Administrative Approval of Minor Site Plan amendment to reflect new west building footprint and minor changes to adjacent parking

RE: SAGEBRUSH COMMUNITY CHURCH
REQUEST FOR ADMINISTRATIVE AMENDMENT
6440 COORS BLVD NW ALBUQUERQUE NM 87120
TR 1DIA ALBAN HILLS UNIT 1 BLOCK 15
ZONE ATLAS PAGE D-12-Z

Tierra West, LLC, on behalf of Sagebrush Community Church, requests approval for an Administrative Amendment to the Site Development Plan for the above referenced project. The project is located at Coors Blvd. NW Albuquerque NM 87120. The request is for a minor modification to the west building (Building A) footprint and adjacent parking. The proposed 8,294 sf building is 286 sf less than Building A footprint shown on the previously approved site plan amendment. The parking in front of the building entrance was modified and does meet code. No parking stalls were eliminated and the overall parking remains the same as previously approved

SITE PLAN FOR
BUILDING PERMIT

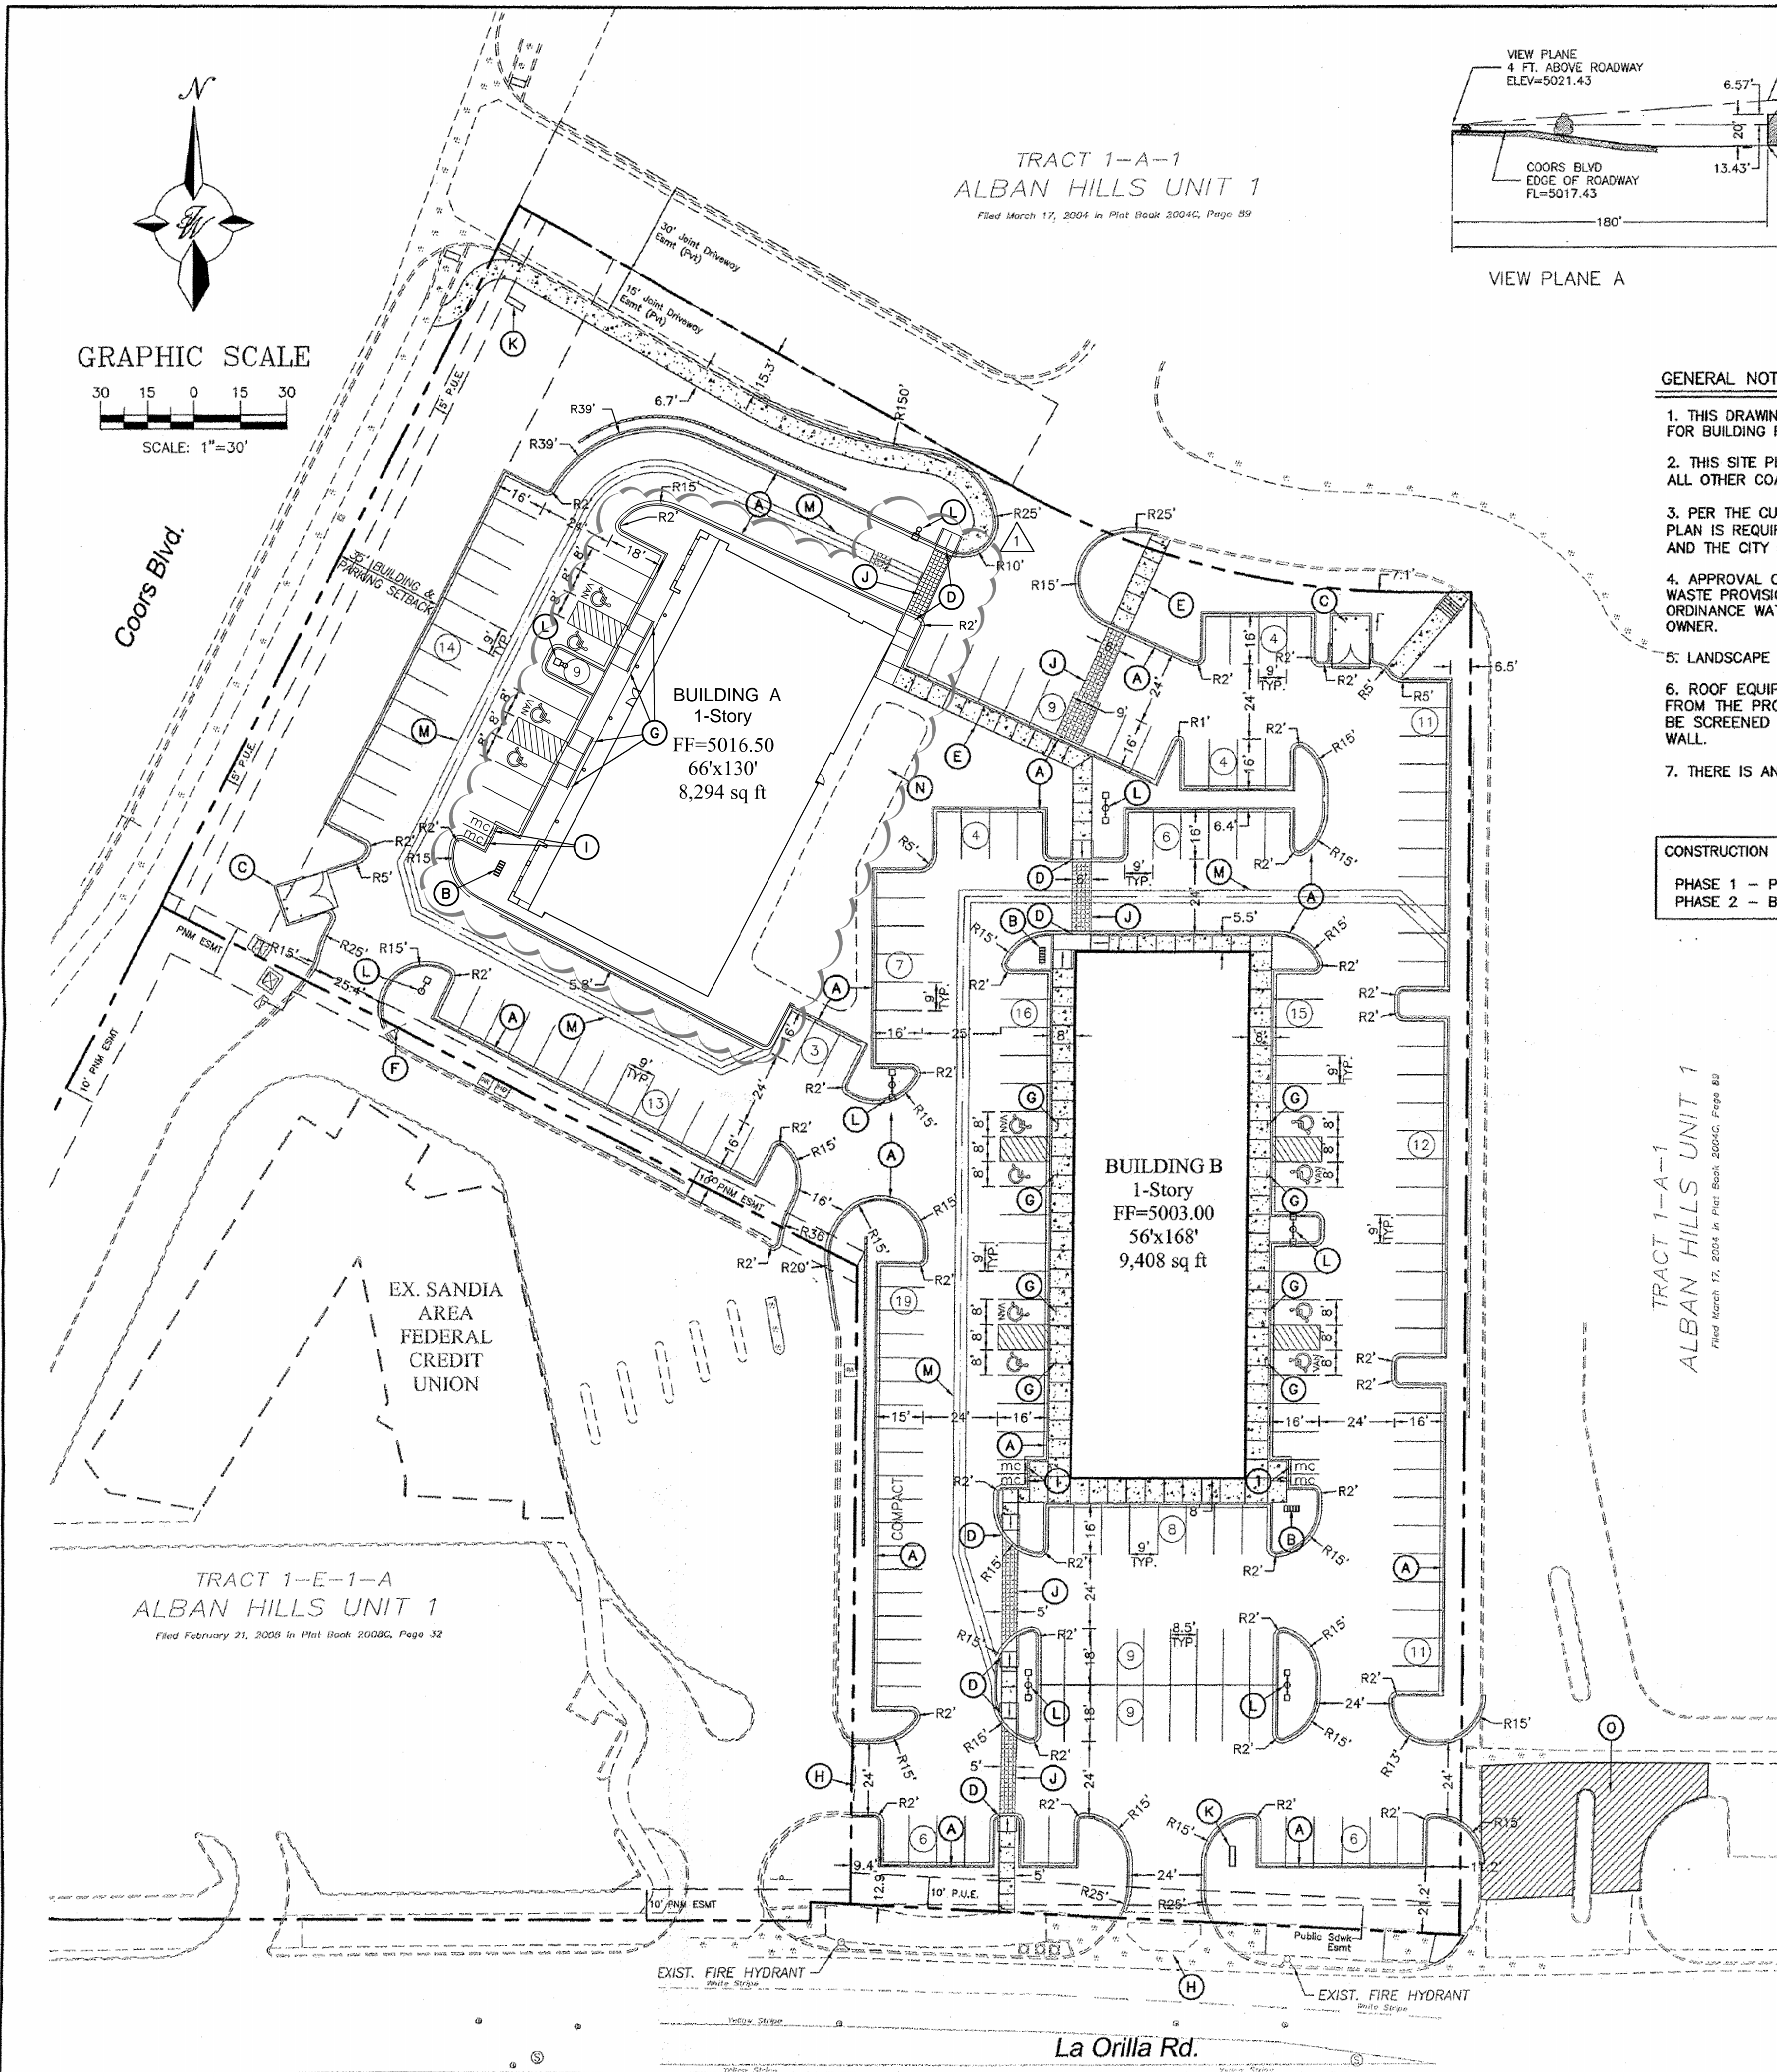
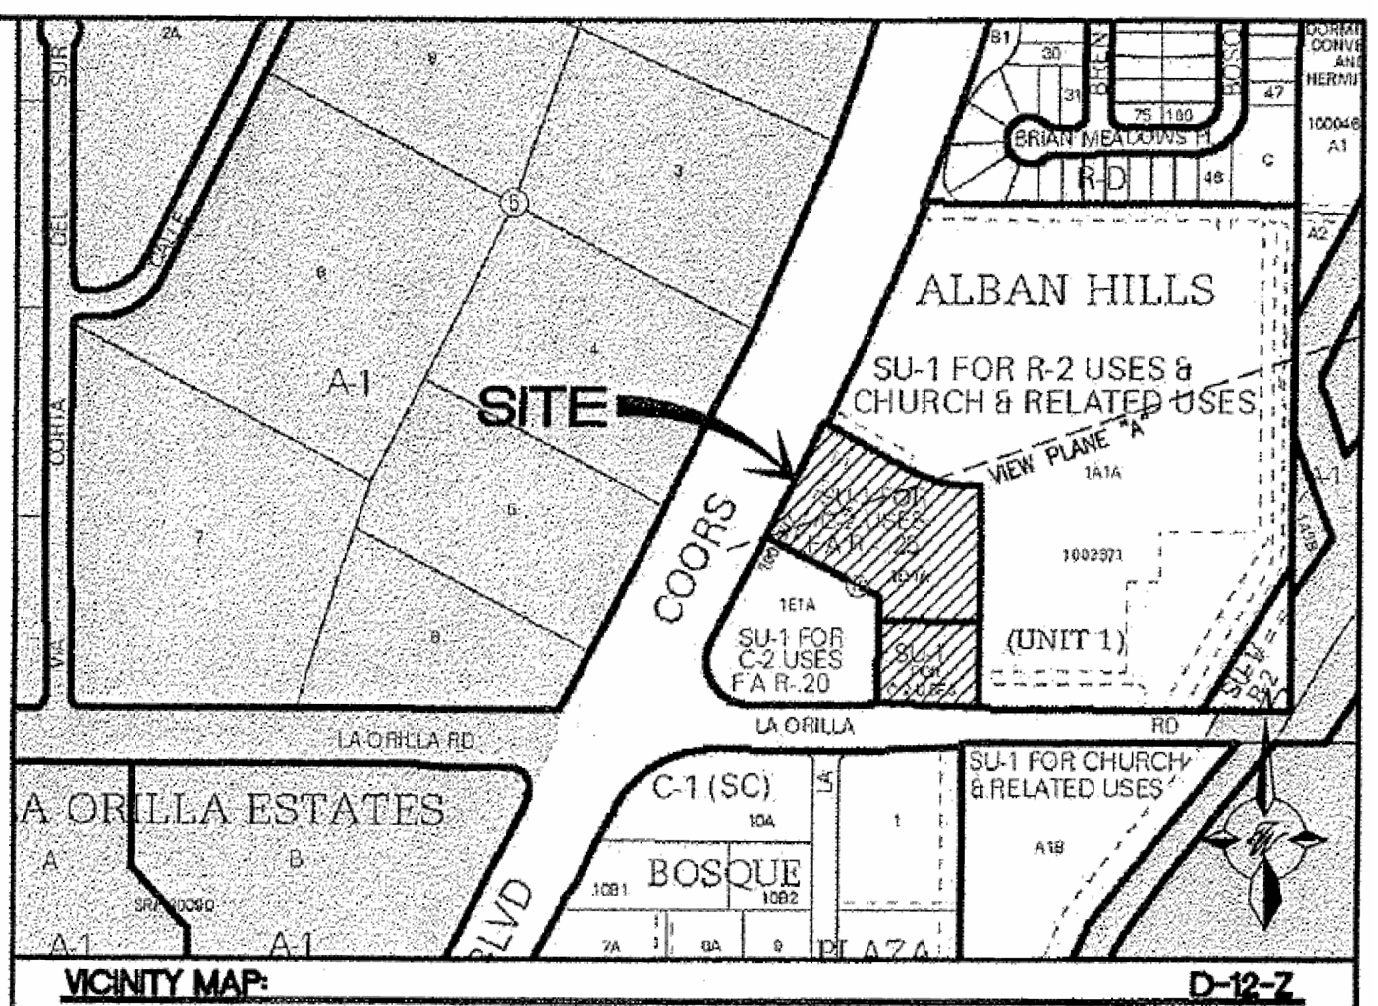
1 REVISED BUILDING / CROSSWALK 11-14-2023
